**ADDENDUM NO. 1
NEW ELEVATOR
AT MURPHY ELEMENTARY SCHOOL
ROUND LAKE SCHOOL DISTRICT NO. 116
PROJECT NO. 23170**

Board of Education
Round Lake School District 116
884 West Nippersink Road
Round Lake, Illinois 60073

S1.1

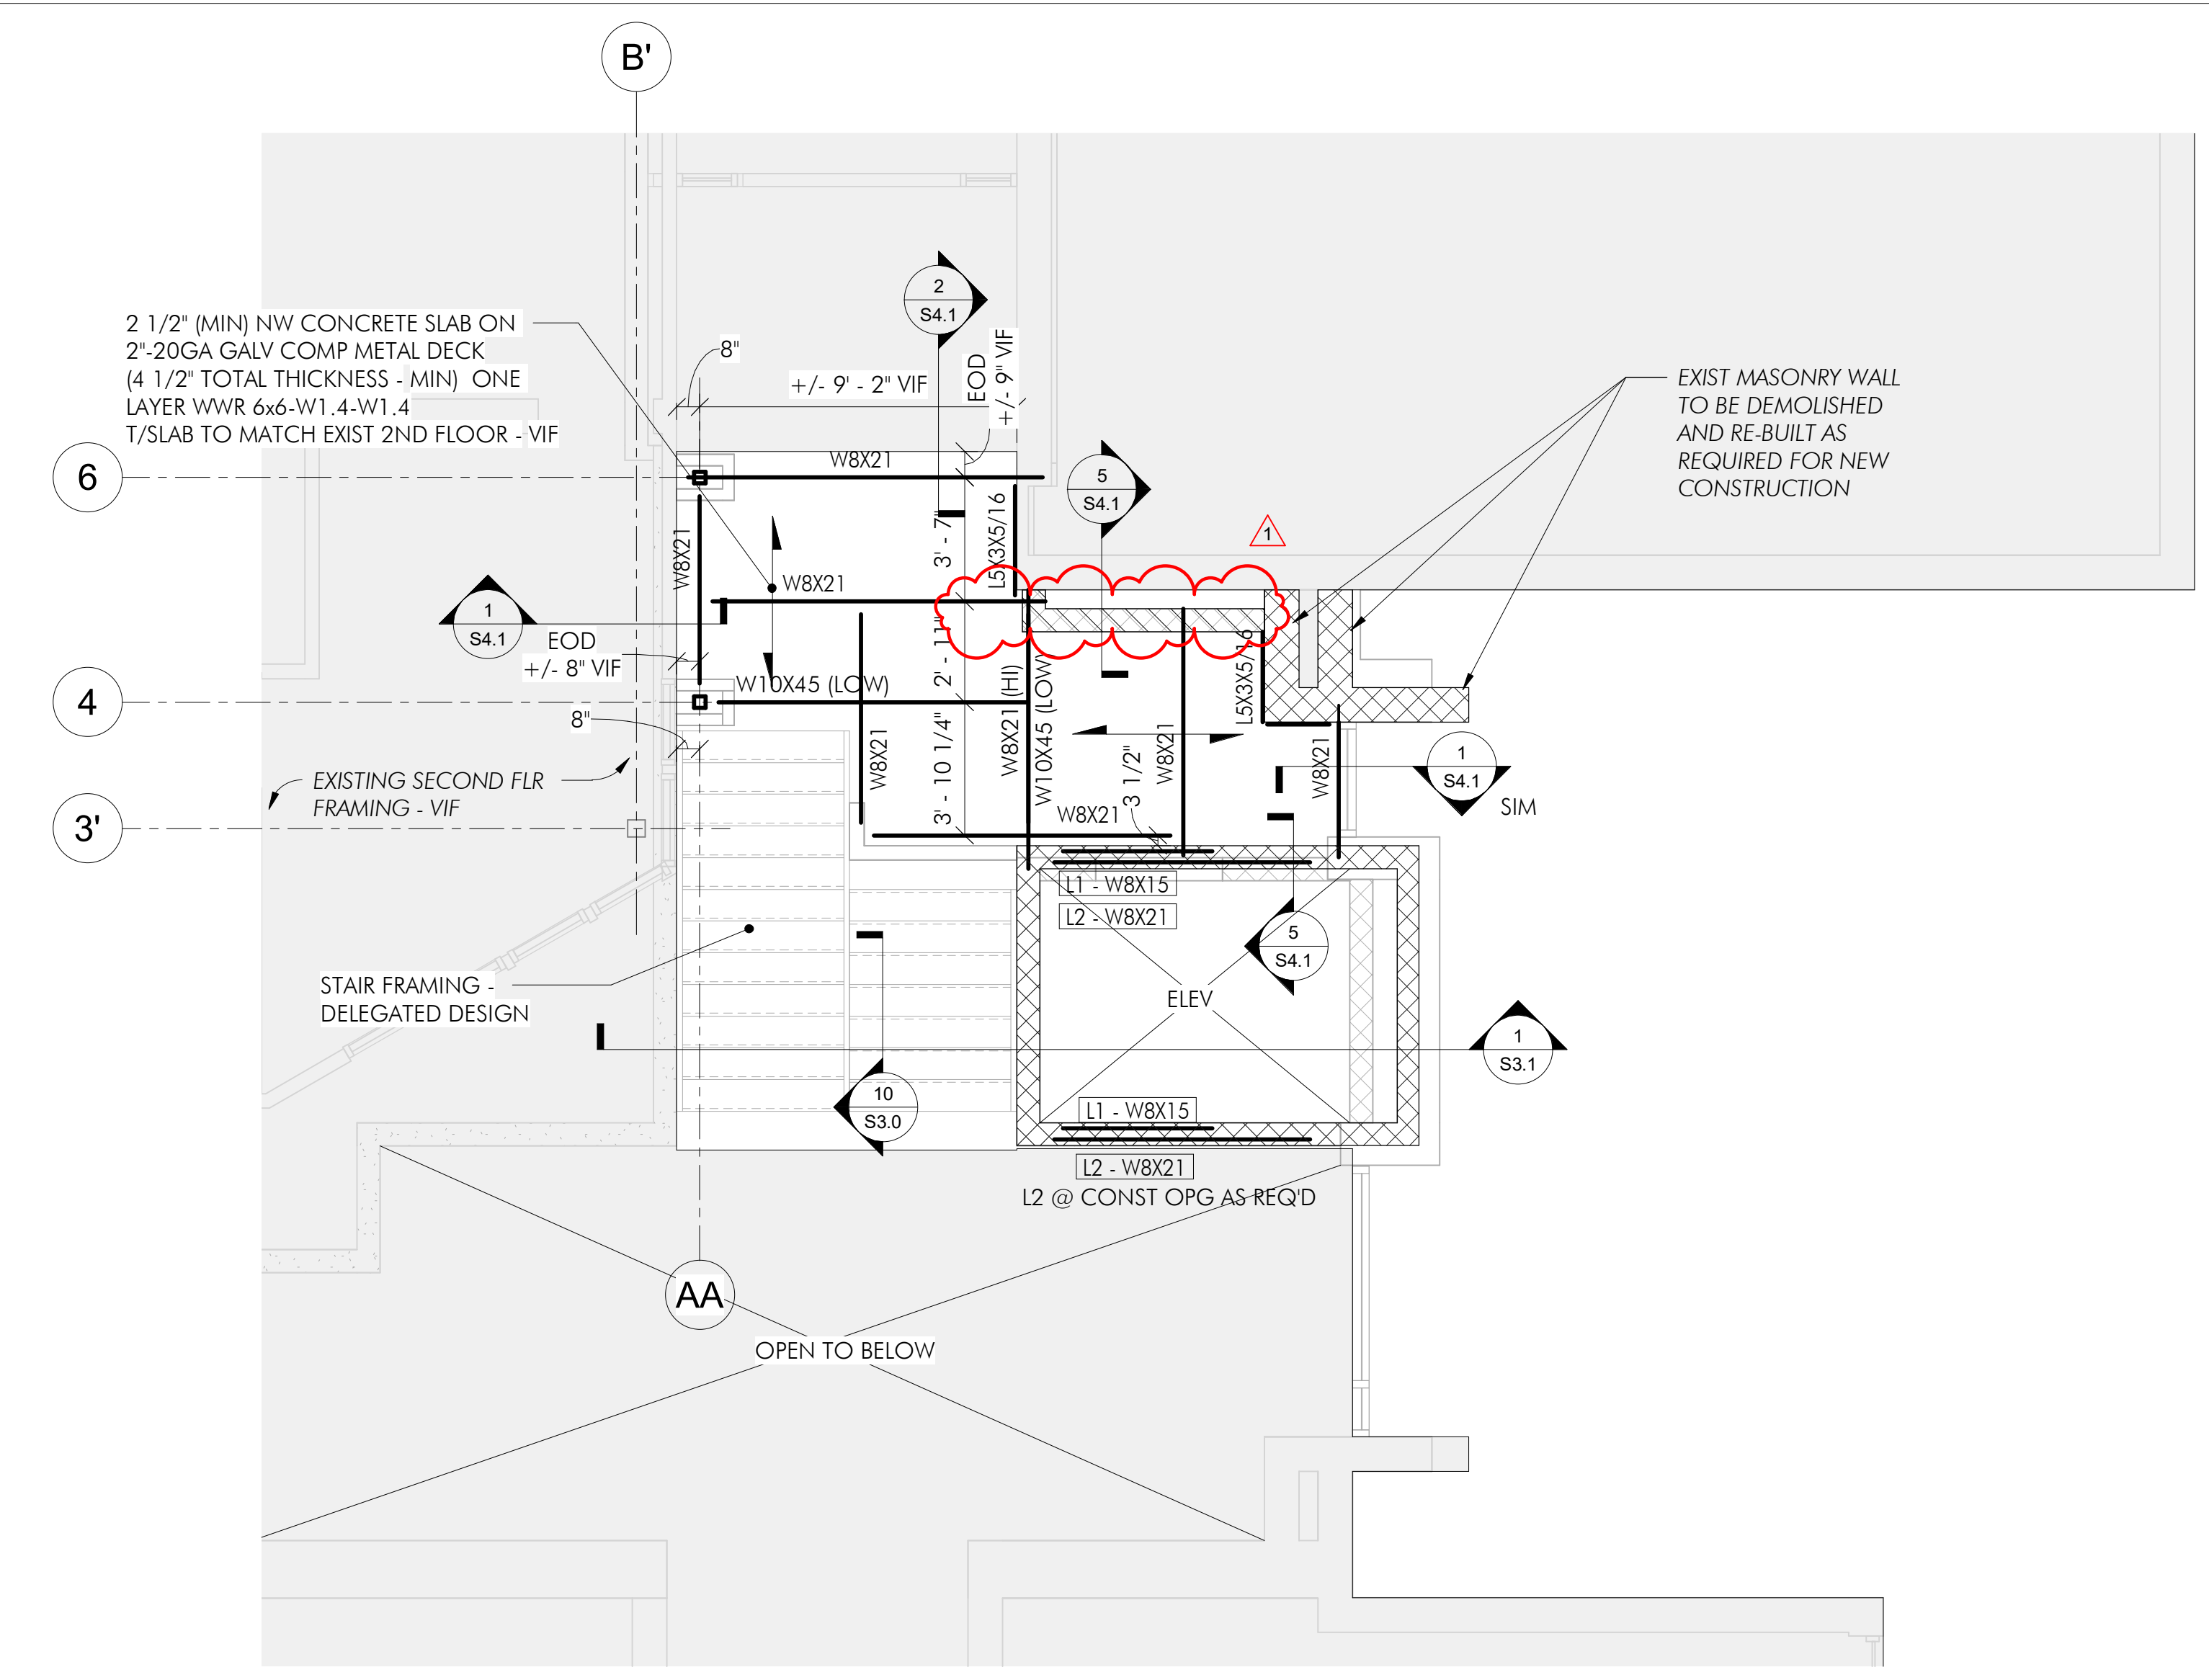
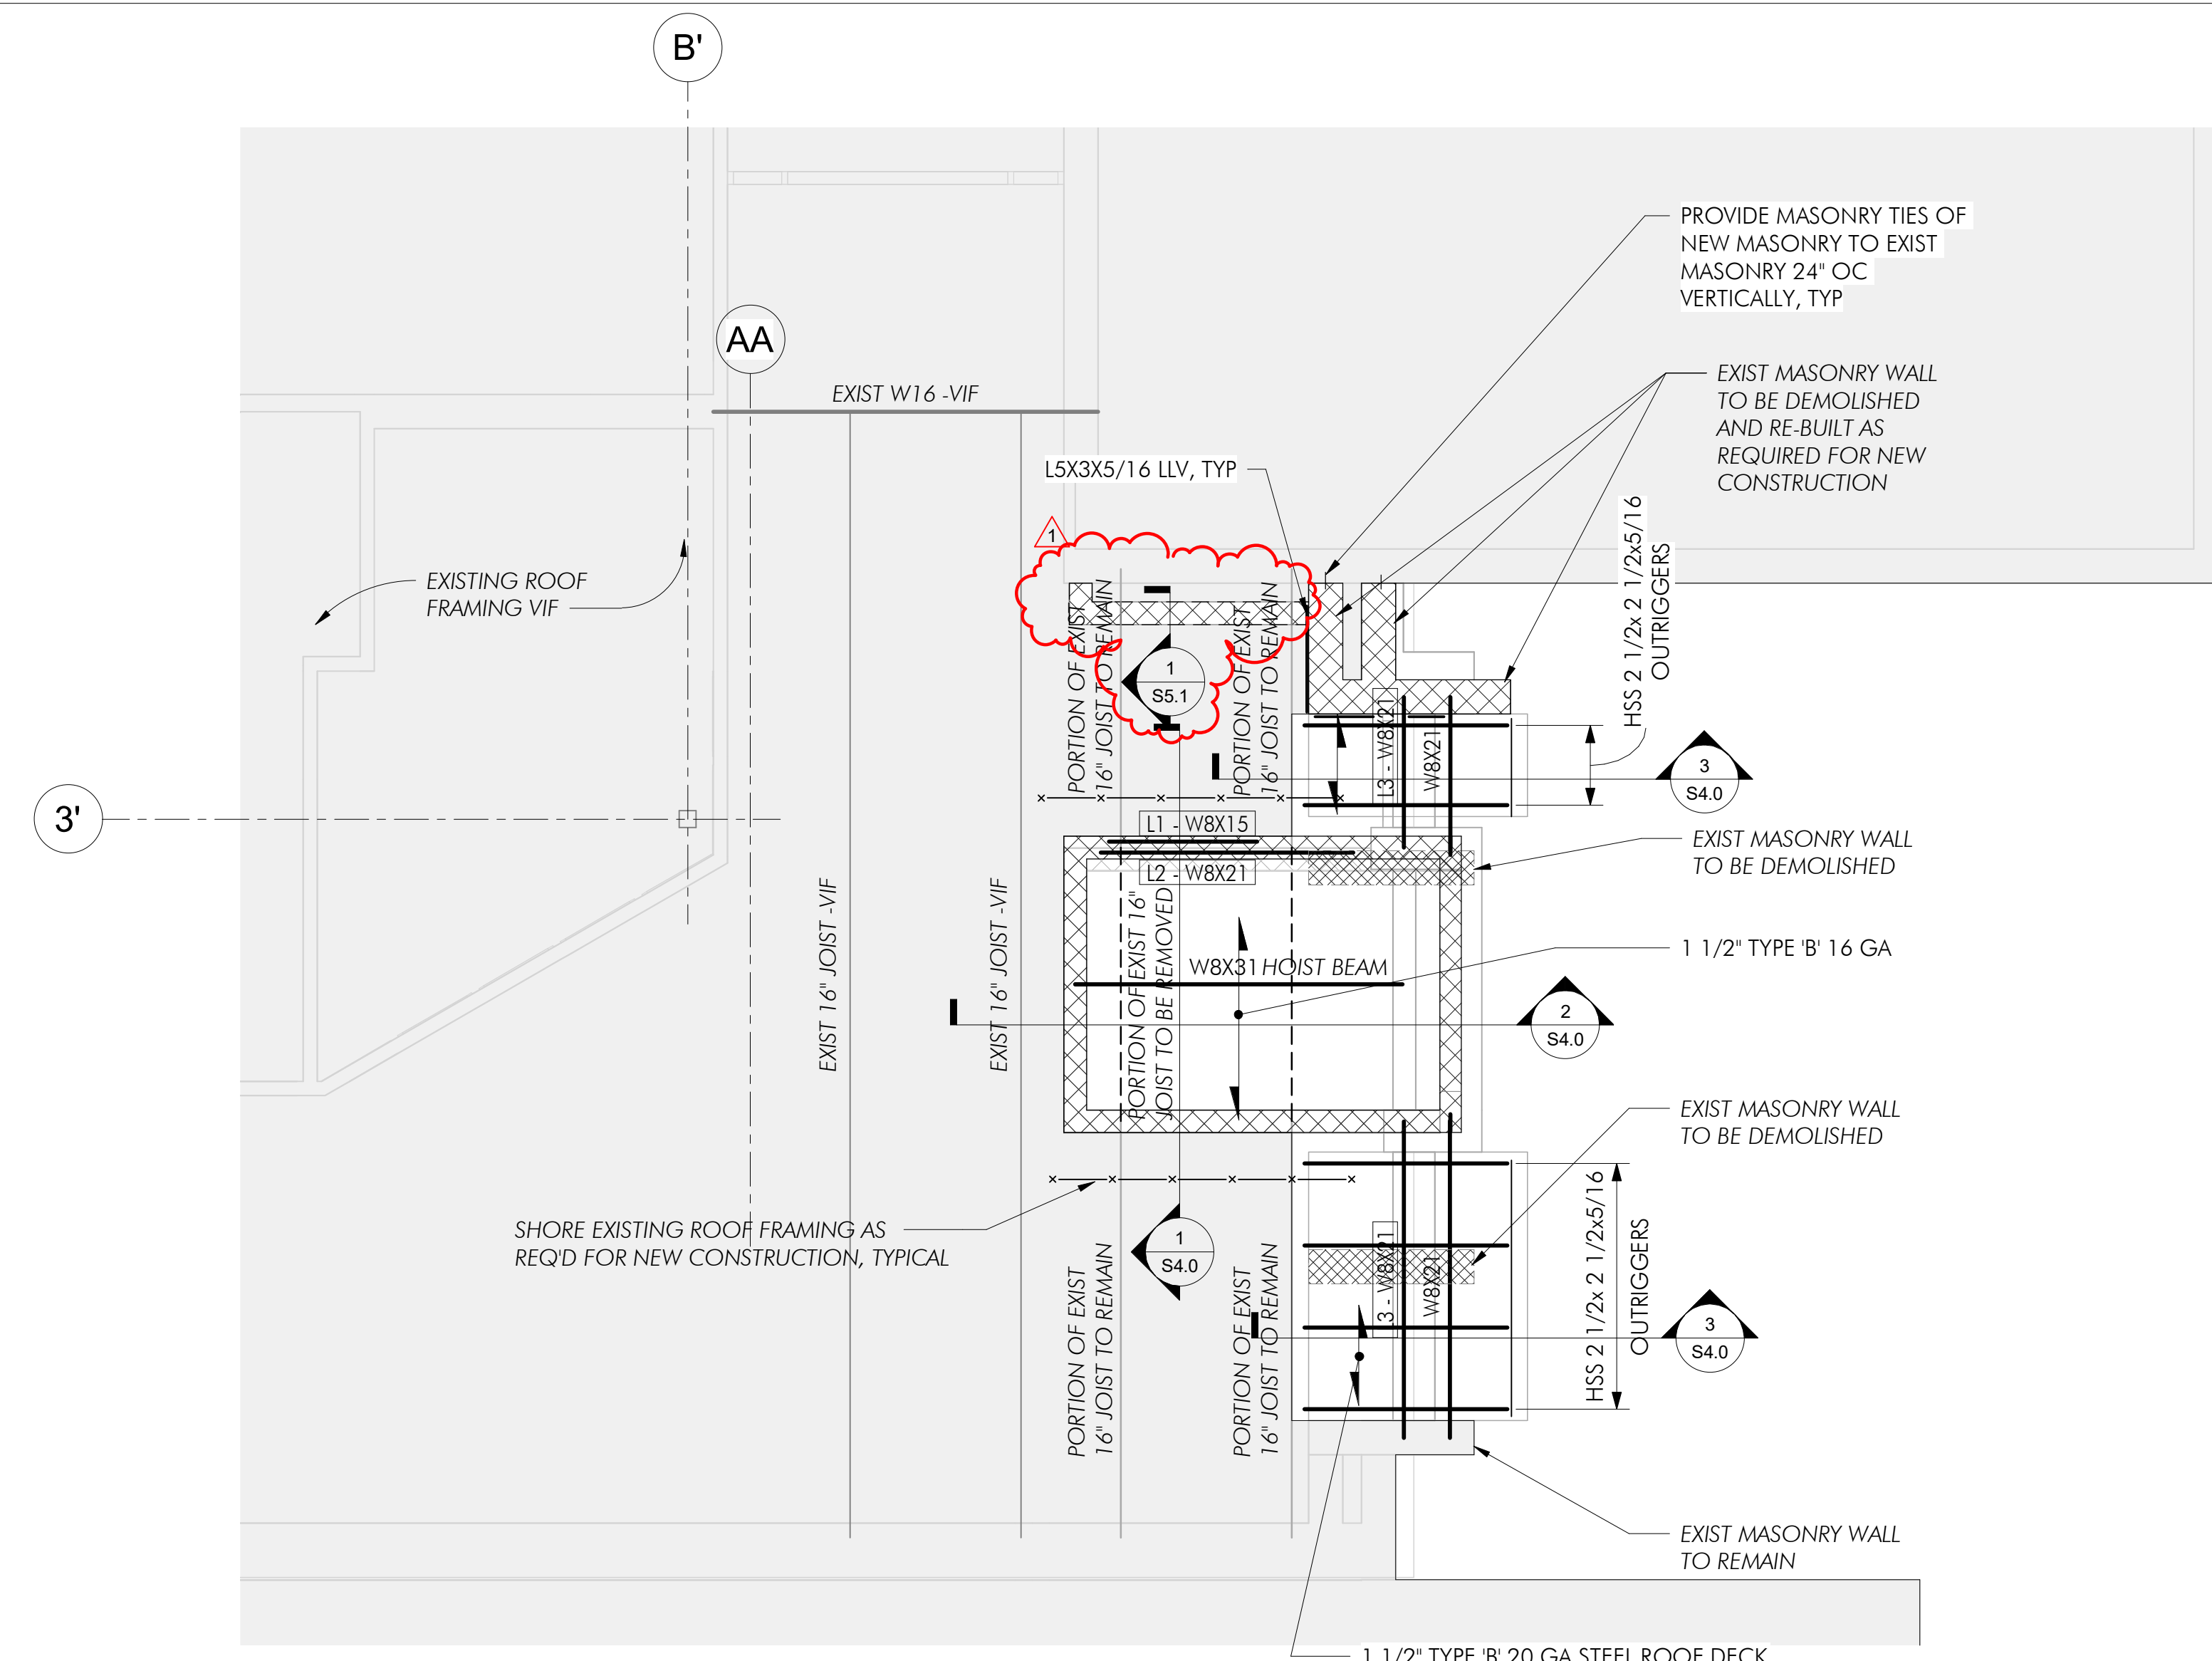
ITEM NO. 4: DRAWINGS, SHEET S1.1, PARTIAL FOUNDATION PLAN, SECOND FLOOR & ROOF FRAMING PLANS

1. Revise Foundation and Framing Plans 1, 2 & 3/S1.1 as shown on attached Sheet S1.1.
